ADDENDUM NO. 3

August 13, 2024

READING REGIONAL AIRPORT

MULTIPLE BUILDING RENOVATIONS

SD-003

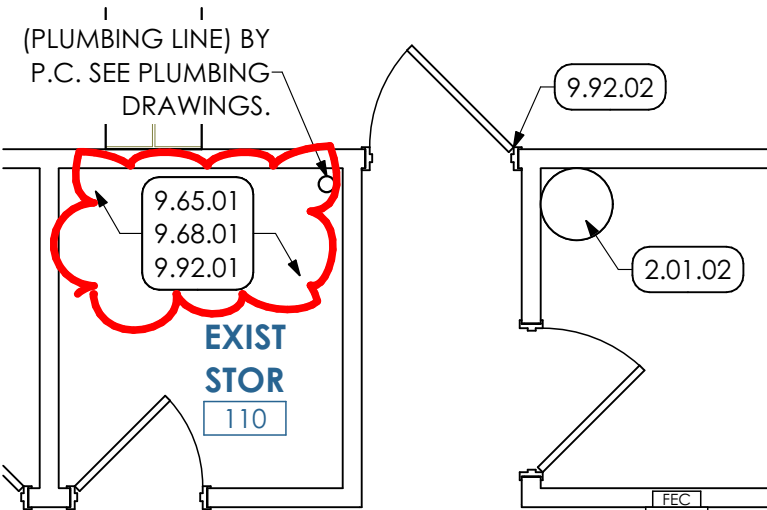
1. **Sheet A-101:** See attached supplemental drawing SD-003, which is attached to and made part of this addendum, for modifications to the keynotes in Room 110 EXIST STOR.
2. **Sheet H-101 – CLARIFICATION:** The electrical work associated with the replacement of the unit heaters is to be included under the HC contract.

1. A-101, A102: Room 110, Existing Storage
 - Notes to keep existing carpet and wall base, but saw cutting floor for plumbing
 - (We were in there today...I did not get a picture, but there is no existing vinyl base, and the carpet is a loose extra piece. I suggest changing to new carpet and vinyl base) **Provide new carpet and base within this room. This will be clarified in an upcoming addendum.**
2. A-110, Keynote 09.92.10 – is there a specified prep for the floor paint? Scarification? Sanding? **The preparation is per the manufacturers requirements. At a minimum I would suggest cleaning and removing any loose paint.**
3. A-121, detail 3. Are the existing roof layer materials verified (by core sample)? **No, core samples were not taken.**

2.41.06 REMOVE EXISTING CARPET FINISH FLOOR INCLUDING ALL ADHESIVES AND UNDERLAYMENTS FOR EXTENTS SHOWN.

9.65.01 4" RUBBER BASE CONTINUOUS FOR PERIMETER OF ROOM.

9.68.01 CARPETING THROUGHOUT ENTIRE ROOM.
